Subject: Request for Relief from American Society of Mechanical Engineers Boiler and Pressure Vessel Code (ASME Code) Inservice Inspection Requirements at the Davis-Besse Nuclear Power Station – Third Ten-Year Interval (RR-A21 and RR-A22) (TAC MB3843)

**REQUEST FOR ADDITIONAL INFORMATION
RR-A21**

DBNPS ISI Program – Third Ten-Year Interval
Relief Request RR-A22

Figure 1: Path 1 Flaws

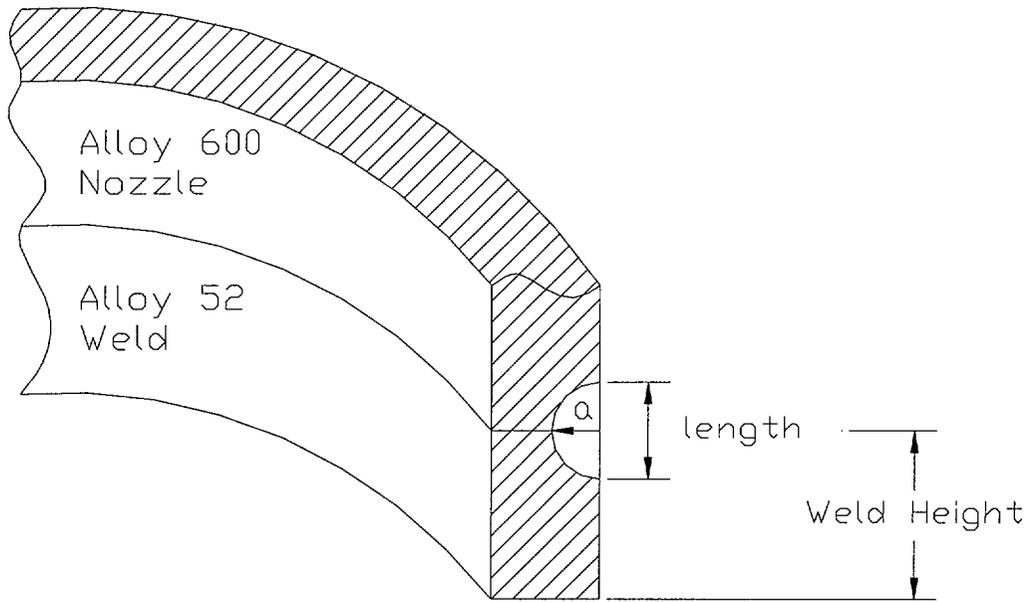
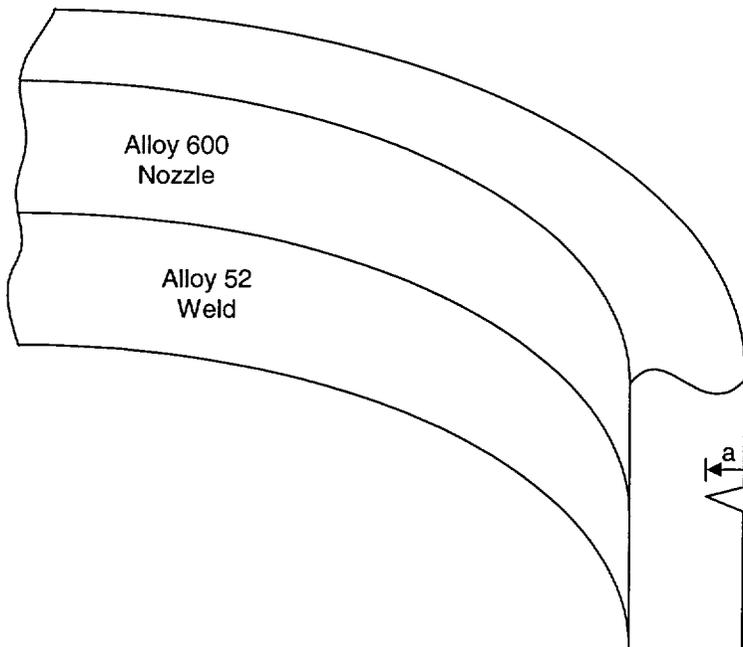
4. Please provide a drawing showing orientation and growth direction of flaws described as Path 1 and Path 2 on pages 6 and 7. Drawing should show *a* and *l* orientation of the flaw.

Path 1 and Path 2 are provided in Figures 1 and 2, respectively. Path 1 assumes either an axially oriented or a circumferentially oriented flaw (with respect to penetration) propagating radially from the triple point to the inside surface of the CRDM nozzle to form a leak path. The initial flaw size is assumed to be 0.100 inches through the weld for the axially oriented flaw and 0.100 inches through the weld, extending the entire penetration circumference, for the circumferentially oriented flaw.
